**CITY OF REDMOND**  
Engineering Department

**2010 PUBLIC WORKS STANDARDS & SPECIFICATIONS**  
**SPECIAL PROVISIONS**

**DATE: 1-1-16 – Check City website for most current version**

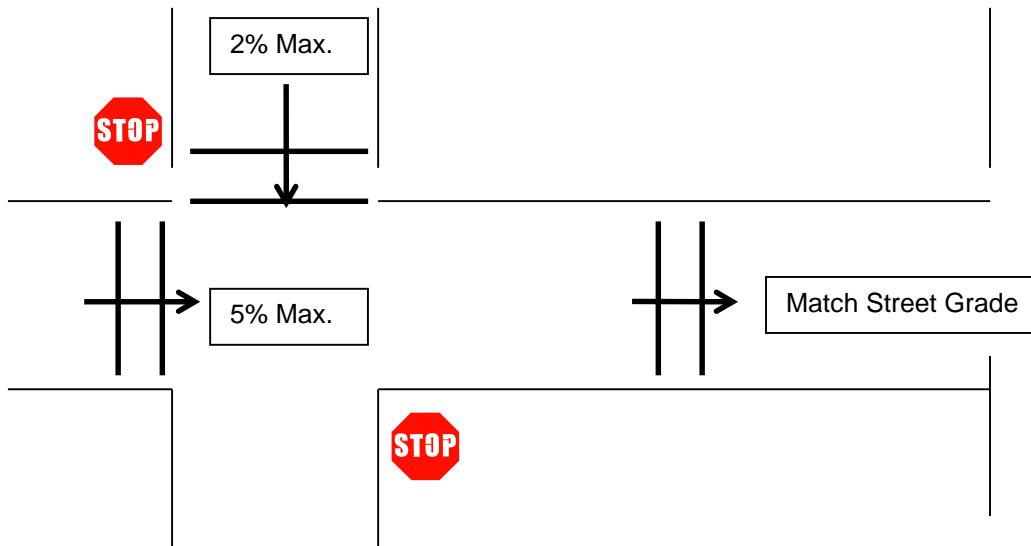
Section II.A.2 Slope: Add the following to the second paragraph: **Note that Draft Public Rights of Way Accessibility Guidelines (PROWAG) specify maximum cross slopes of pedestrian street crossings which will control the longitudinal grade of the street at intersections. In accordance with PROWAG Section 302.6, the maximum cross slope of the pedestrian crossing for stop or yield controlled streets shall be 2 percent. For streets without stop or yield control, the maximum cross slope is 5 percent (R302.6.1). Cross slopes of midblock pedestrian street crossings are permitted to match the grade of the street (R302.6.2).**

Change the third paragraph to read as follows: “To insure that cross slopes are not exceeded during sidewalk ramp construction, maximum slope through intersections shall be 2% in accordance with Standard Drawing 2-27. Detailed slope and elevation information shall be provided for sidewalk ramps and curb returns and shall conform to Draft Public Rights of Way Accessibility Guidelines (PROWAG) published by the Department of Justice. Note that the minimum continuous and unobstructed clear width of a pedestrian access route shall be four feet (PROWAG **R302.3**). The maximum cross slope of the walkway shall be two percent (PROWAG **R302.6**). Pedestrian access routes running parallel to a street may run at the same grade as the street, but cannot exceed the street grade (PROWAG **R302.5**). Options for ramp layout at intersections are provided in the standard drawings. Slopes and widths of landings, wings and other components must comply with Section **R304** of PROWAG. It is recommended that design slopes be set lower than the PROWAG maximum to allow for discrepancies during construction.
